CASE INFORMATION

CASE	UDP-S24072
PROJECT NAME	Broward Health Medical Center (BHMC) Medical Office Building and Parking Garage
APPLICATION TYPE	Site Plan Level II
APPROVAL LEVEL REQUEST	City Commission Approval Design Deviations for Additional Building Height Greater than 110 Feet in Height for 204,589 Square Feet of Medical Office Use
APPLICANT AGENT	North Broward Hospital District Stephanie Toothaker, Esq.
PROPERTY ADDRESS	1601, 1603, 1611, 1627, and 1632 S. Andrews Avenue
ABBREVIATED LEGAL DESCRIPTION	Croissant Park Resub Blk 38 52-8 B Lots 1 To 12, 17 and 18, 21 To 24
ZONING DISTRICT	South Regional Activity Center-South Andrews east (RAC-SAe)
LAND USE	South Regional Activity Center
COMMISSION DISTRICT	4 - Ben Sorensen
NEIGHBORHOOD ASSOCIATION	Poinciana Park Civic Association
SUBMITTAL	December 13, 2024
COMPLETENESS ISSUED	December 19, 2024
EXPIRATION	June 17, 2025 (180 Days)
WAIVER	Not Requested
CASE PLANNER	Adam Schnell Urban Planner III

Case Number: UDP-S24072

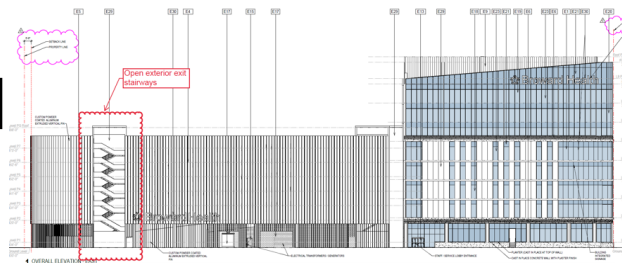
7. **New Comment:** I noticed the open exterior exit stairways show below, which are not allowed per Section 1027.2 of the FBC for high-rise buildings. If the parking garage and medical building are separate buildings with the required fire wall rated assemblies from the foundation to the roof deck, then this is not an issue. Please consult with the design team and let me know.

I noticed the open exterior exit stairways show below, which are not allowed per Section 1027.2 of the FBC for high-rise buildings. If the parking garage and medical building are separate buildings with the required fire wall rated assemblies from the foundation to the roof deck, then this is not an issue. Please consult with the design team and let me know. Note that the parking garage would not be considered a high-rise since is less than 75 ft to the occupiable floors.

Can you add a note on the drawings addressing this issue.

REV 2 Response: The garage is not a high-rise, the garage height to highest occupied floor P-7 is at 73' which is less than 75'. 3-hour rated fire wall separates the garage from MOB tower. Please see architectural General and code information sheet G1.01.1, G2 Code compliance series, and Exterior elevations on A7 series

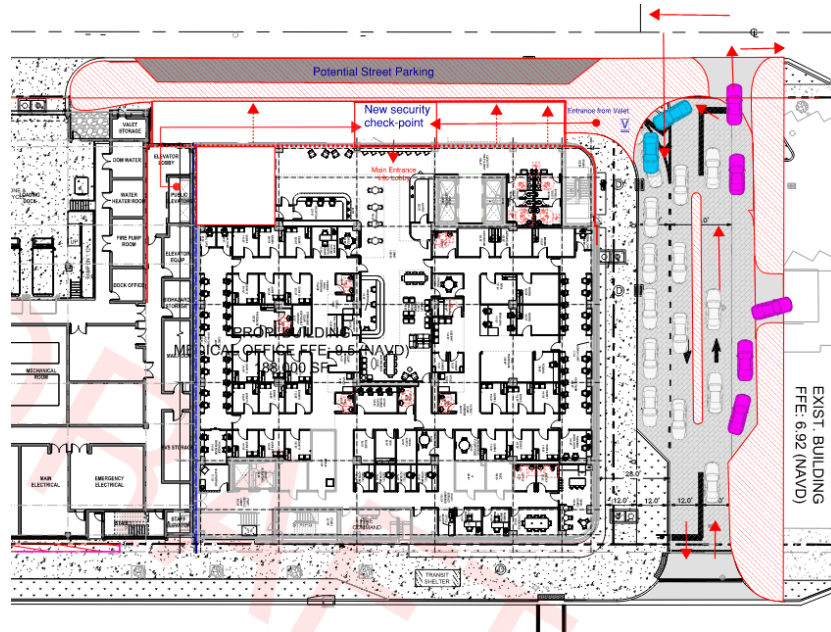
Comment 4/11/2025: Construction fence still encroaching onto 25 x 25 visibility triangles. To be addressed at time of permitting.

REV 2 Response: Noted, construction fence has been adjusted away from visibility triangles. Refer to revised plans.

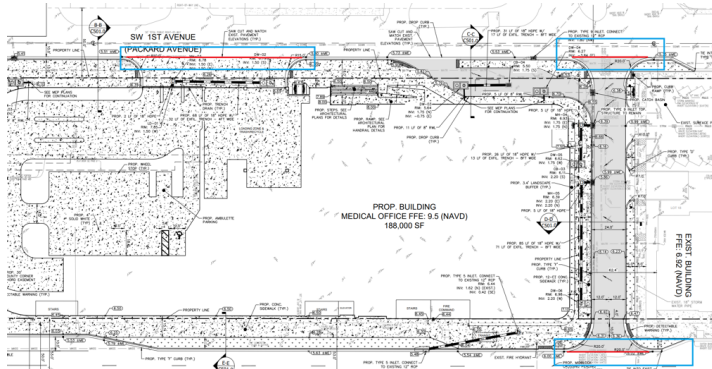
Comment 4/11/2025: Please clearly show proposed drop curbs along site entrances and loading zone. See below for reference:

REV 2 Response: Drop curbs have been added as requested.

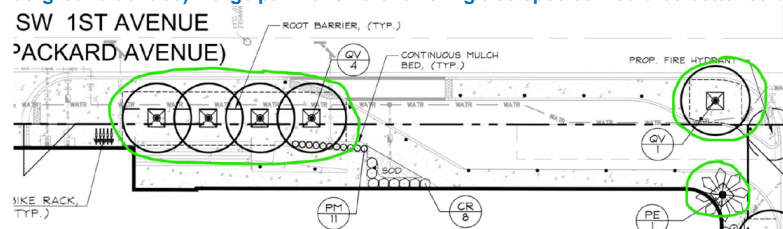
a. See below for example of conflict between civil and landscape plans along SW 1st AVE. Civil plans propose existing water main to be cut, plugged and abandoned. New main to be installed within ROW, south of the proposed garage entrance curb cut. Please coordinate landscape plans to match. Street trees in this area won't require root barrier for abandoned main and can be specified at full size with structural soil.

REV 2 Response: Plans have been updated per request, refer to revised plans.

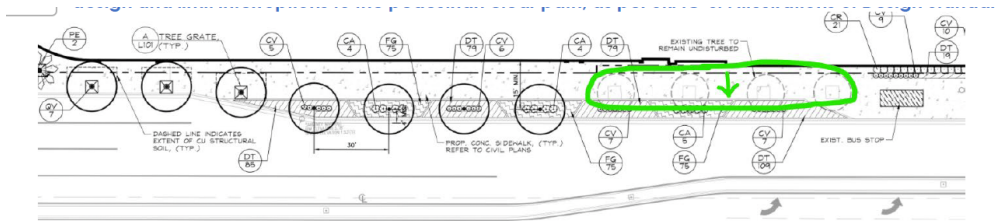
1. Please propose relocation of existing Live Oak street trees #027, 029, 033 & 037 along S ANDREWS AVE to the newly proposed ROW landscape buffer area directly to their east. If relocation(s) are not feasible per ISA Certified Arborist recommendation, Landscape staff would prefer removal and replacement with new Live Oak street trees within the ROW landscape buffer area. This is to provide continuity of streetscape design and limit interruptions to the pedestrian clear path, as per SRAC-SA Illustrations of Design Standards.

REV 2 Response: Existing Oak trees to be accessed for relocation feasibility per the comments. In the event these Oaks are not viable candidates for relocation, then they will be removed and replaced at a 1:1 rate within the proposed landscape buffer strip along the roadway, matching the design intent of the four proposed Oaks directly adjacent.

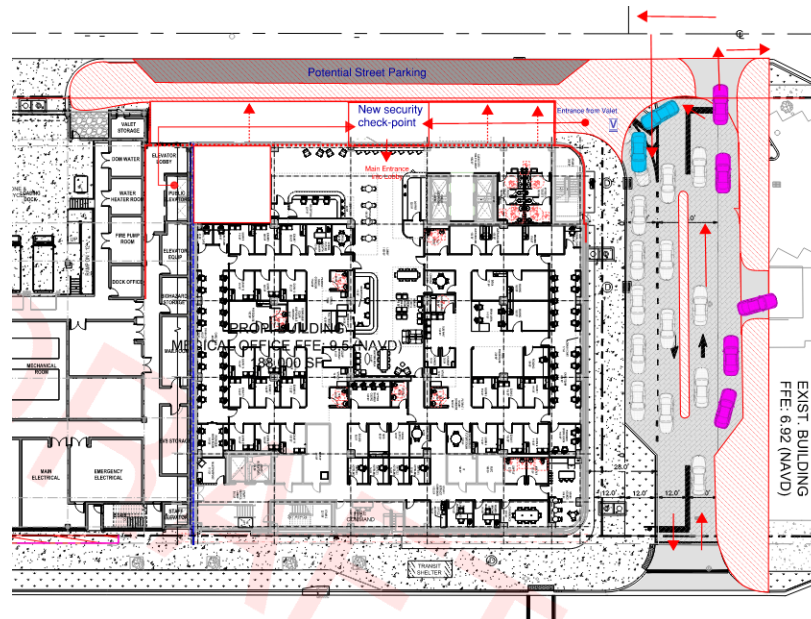
- o. Per the SRAC Master Plan the maximum travel lane width shall be ten feet. Increase the sidewalk and swale width of SW 1st avenue and remove the drop-off lane that encroaches into the public right-of-way, as well as any sidewalk pinch points. With the removal of the drop-off lane additional trees can be provided. Because no on-street parking is being provided, an approximate 12-foot-wide unobstructed sidewalk can be provided, with a 10-foot-wide landscape swale, and two-foot curb and gutter. Reference image below for additional context. Note: Consider internalizing the drop-off between the existing and proposed building on the vacated portion of SW 16th Street. Reference the image below for additional context.

Decrease lane width to 10-feet per the SRAC Mast Plan and extend sidewalk, and swale system

Remove drop-off lane, increase sidewalk width and remove sidewalk pinch points.

REV 1 Response: Lane width along SW 1st Avenue has been decreased to 10 feet in accordance with the SRAC Master Plan. Drop-off lane has been reconfigured to provide continuous sidewalk transit. Refer to sheet C200.0 and C500.0.
